ADDENDUM NO. 1
May 18, 2022

PROJECT: CITY OF AMHERST
WATER SYSTEM BACKUP GENERATORS

1) PLAN SHEETS – SHEET 2

CITY OF AMHERST
 WATER SYSTEM BACKUP GENERATORS
 CONSTRUCTION DRAWINGS
 WELL BUILDINGS ELECTRICAL LAYOUT

SHEET 2

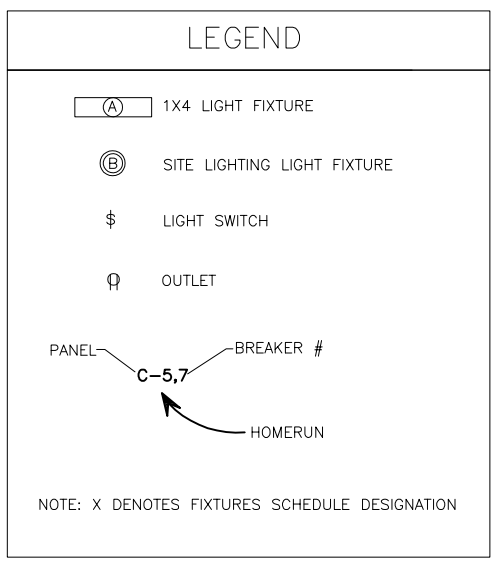
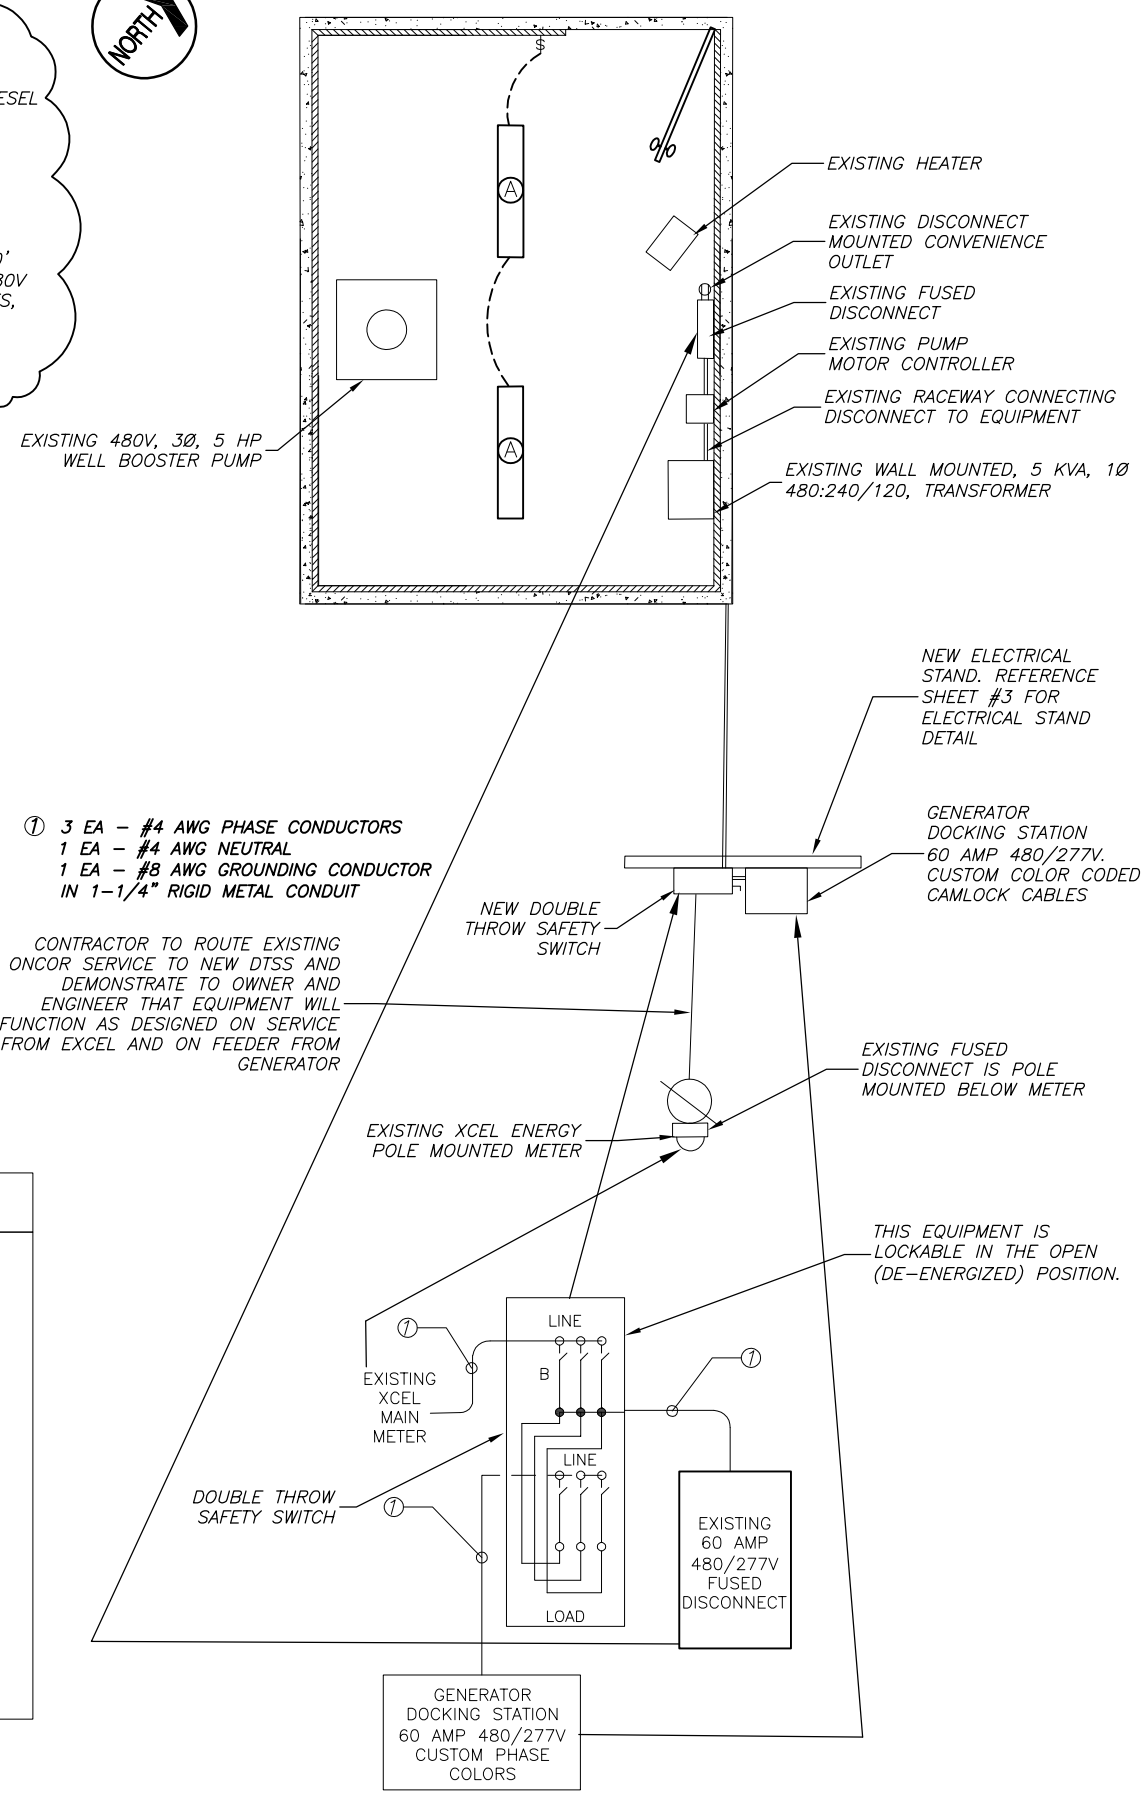
- a) Note #1 has been changed on sheet #2 to remove the requirement for a load bank on the generator. Note #1 now reads that “the contractor to provide trailer mounted diesel generator that will meet EPA requirements. See the attached revised sheet 2.
- b) Note #3 has been added. Note #3 reads, “the bidder will be required to provide 50’ cam lock cables, color coded for the 480V water well sites. There will be five cables, 3 phase cables, 1 neutral, and 1 ground. See the attached revised sheet 2.

1. CONTRACTOR TO PROVIDE TRAILER MOUNTED DIESEL GENERATOR THAT WILL MEET EPA EMISSION REQUIREMENTS.
2. EXISTING EQUIPMENT AND LIGHTS ARE FOR REFERENCE ONLY. ELECTRICAL CONTRACTOR TO VERIFY EXACT LOCATION.
3. THE BIDDER WILL BE REQUIRED TO PROVIDE 50' CAM LOCK CABLES, COLOR CODED FOR THE 480V WATER WELL SITES. THERE WILL BE FIVE CABLES, 3 PHASE CABLES, 1 NEUTRAL AND 1 GROUND CABLE.
